# Access Compliance Report

## Public Rights-of-Way

### (Curb Ramps)

Intersection ID: 47972	Main Street: ALHAMBRA_LN	Cross Street: SOUTH_CREEK_RD	Location: W
ADA ID: 095616CF1E1B	Ramp Type: PerpDiag	Initial Pass/Fail: Fail	Overall Compliance: No
		Severity Score: 10

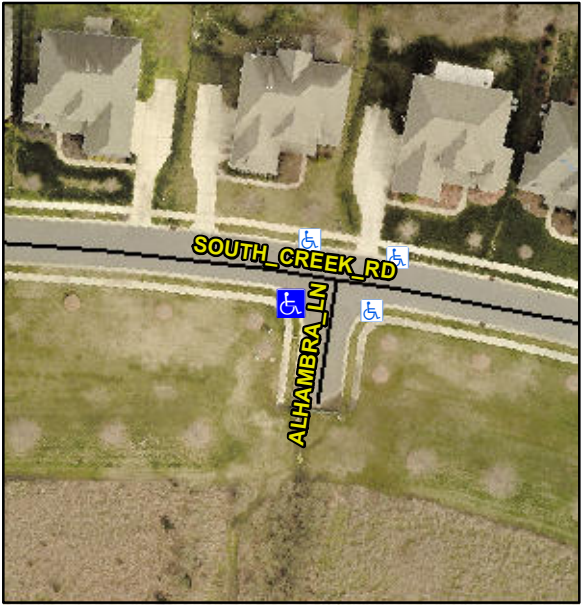
Codes/Mitigation Info/Possible Solution		Field Measurements/Component Compliance			
	Possible Solutions:	Compliance	Description	Data	
	Remove & Replace Curb Ramp With Two New Directional Ramps or Equivalent.	N/A	Ramp Length (in)	47.0	Yes
		No	Ramp Width (in)	46.0	No
		N/A	Flare Type LT	N/A	N/A
		N/A	Flare Slope LT (%)	N/A	N/A
		N/A	Flare Traversable LT?	N/A	N/A
		N/A	Landing Length (in)	N/A	N/A
		N/A	Landing Width (in)	N/A	N/A
		N/A	Landing Slope (%)	N/A	N/A
		N/A	Landing X Slope (%)	N/A	N/A
<p>Surveyor Notes:</p> <p>N/A</p> <p>PROW/ADA:</p> <p>R304.5.1, R304.5.3</p>		N/A	Flare Type RT	N/A	N/A
		N/A	Flare Slope RT (%)	N/A	N/A
		N/A	Flare Traversable RT?	N/A	N/A
		N/A	DWS Provided?	N/A	N/A
		N/A	DWS Contrast?	N/A	N/A
		N/A	DWS Length (in)	N/A	N/A
		N/A	DWS Full Width?	N/A	N/A
		N/A	DWS Offset (in)	N/A	N/A
		N/A	Shared Landing?	N/A	N/A
		N/A	Gutter Ponding?	N/A	N/A
		N/A	Gutter Lip Ht (in)	N/A	N/A
		N/A	Painted X Walk1?	No	N/A

X Walk 1 Direction	To SE	
		N/A	X Walk 1 Width (in)	N/A	N/A
			X Walk 1 Slope (%)	2.4	
			X Walk 1 X Slope (%)	4.1	
		N/A	Ramp inside XWalk1?	N/A	N/A
			Road Slope (%)	2.3	N/A
			Road X Slope (%)	3.0	N/A
		N/A	Any Obstructions?	N/A	N/A
Total Cost:		\$	3200.00		
			Obstruction Type		
				N/A	N/A
				Yes	Surface Condition? (G/P)
					Good
